**COMMENTS OF HEARTH, PATIO & BARBECUE ASSOCIATION ON EPA'S
PROPOSED STANDARDS OF PERFORMANCE FOR NEW RESIDENTIAL WOOD
HEATERS, NEW RESIDENTIAL HYDRONIC HEATERS AND FORCED-AIR
FURNACES, AND NEW RESIDENTIAL MASONRY HEATERS**

Docket ID No. EPA-HQ-OAR-2009-0734

May 2, 2014

b. NERA's Analysis Shows that EPA's Proposed Step 2 and 3 Standards Are Not Cost Effective

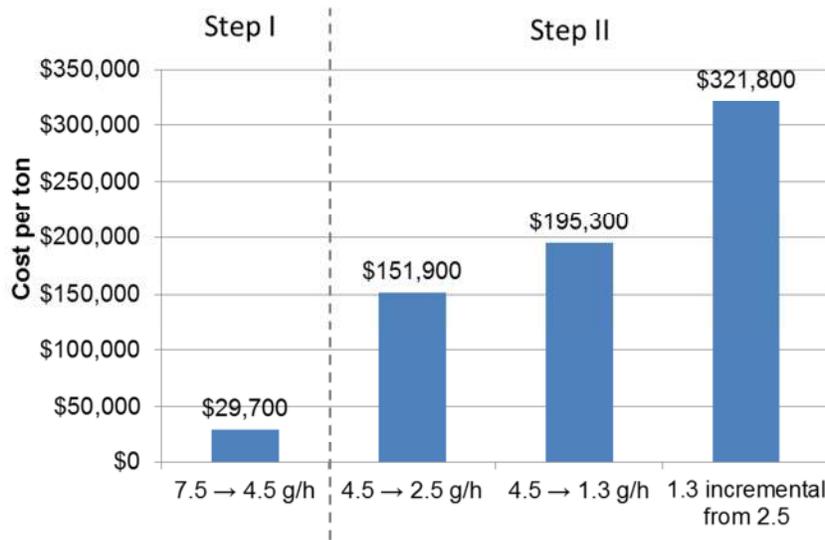
The full details on NERA's data inputs and methodology can be found in the appendices attached to their analysis, and we will not summarize those details here. In short, NERA evaluated the cost-effectiveness of increasingly stringent particulate matter emissions standards for woodstoves. Using detailed information on compliance costs and economic assessments consistent with EPA guidelines for economic analysis, NERA developed estimates of the incremental cost per ton for three NSPS.

1. Step 1 standard of 4.5 grams per hour (g/hr);
2. Step 2 standard of 2.5 g/hr; and
3. Step 2 standard of 1.3 g/hr.

b. NERA's Analysis Shows that EPA's Proposed Step 2 and 3 Standards Are Not Cost Effective

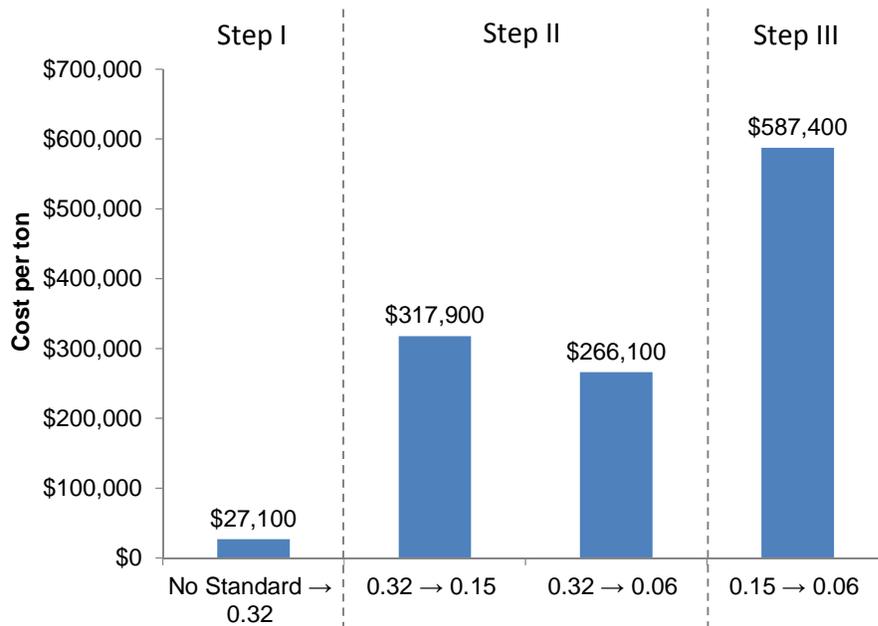
The full details on NERA's data inputs and methodology can be found in the appendices attached to their analysis, and we will not summarize those details here. In short, NERA evaluated the cost-effectiveness of increasingly stringent particulate matter emissions standards for hydronic heaters. Using detailed information on compliance costs and economic assessments consistent with EPA guidelines for economic analysis, NERA developed estimates of the incremental cost per ton for three NSPS.

1. Step 1 standard of 0.32 lb/MMBtu (the current Voluntary Program standard);
2. Step 2 standard of 0.15 lb/MMBtu or 0.06 lb/MMBtu; and
3. Step 3 standard of 0.06 lb/MMBtu (from a Step 2 standard of 0.15 lb/MMBtu).
